Access Compliance Report Public Rights-of-Way (Pedestrian Signals)

Main Street: **NEWLAND_ST** Cross Street: **HAZARD_AVE** Location: **NE**

ADA ID: **SGRK210929115529** Signal Type: **One Push Button-Non APS** Overall Compliance: **No** Severity Scores: **BTN 1: 35** **BTN 2: N/A** **No BTN: N/A**

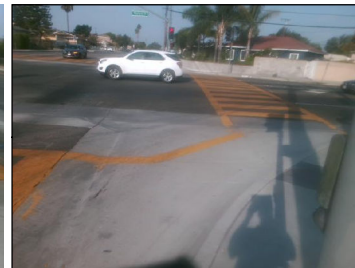
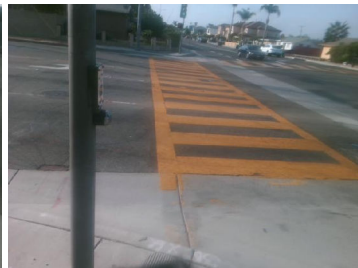
Possible Solutions: Replace Signal Push Button With APS Button. Remove and Replace Clear Space.

OC Std/PROW: R404.2, R404.3, MUTCD 4e.08
